# UNITED STATES PATENT AND TRADEMARK OFFICE

APPLICATION NO.	FILING DATE	FIRST NAMED INVENTOR	ATTORNEY DOCKET NO.	CONFIRMATION NO.
10/540,138	06/21/2005	Georg Riescher	4100-357PUS	8881
27799	7590	06/14/2006		EXAMINER
		COHEN, PONTANI, LIEBERMAN & PAVANE		FERGUSON, MARISSA L
		551 FIFTH AVENUE	ART UNIT	PAPER NUMBER
		SUITE 1210		2854
		NEW YORK, NY 10176

<b>Office Action Summary</b>	<b>Application No.</b>	<b>Applicant(s)</b>	
	10/540,138	RIESCHER ET AL.	
	Examiner Marissa L. Ferguson-Samreth	Art Unit 2854

### **DETAILED ACTION**

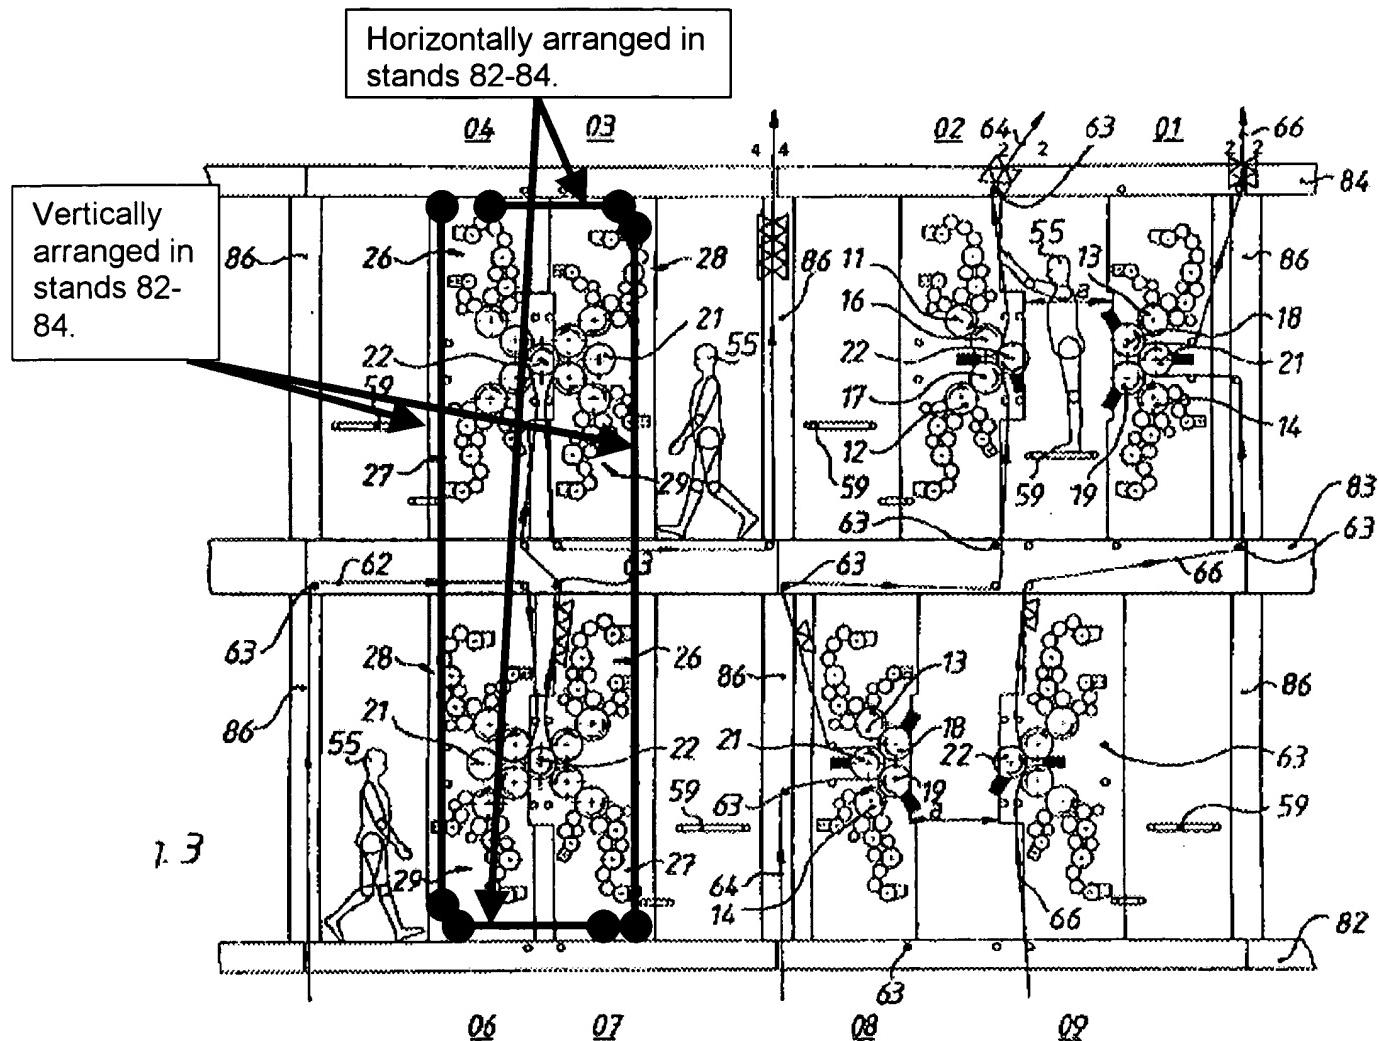
Regarding claim 14, Weschenfelder teaches wherein a crossmember is aligned one of horizontally and vertically in the stand (refer to figure on page 4 of office action).
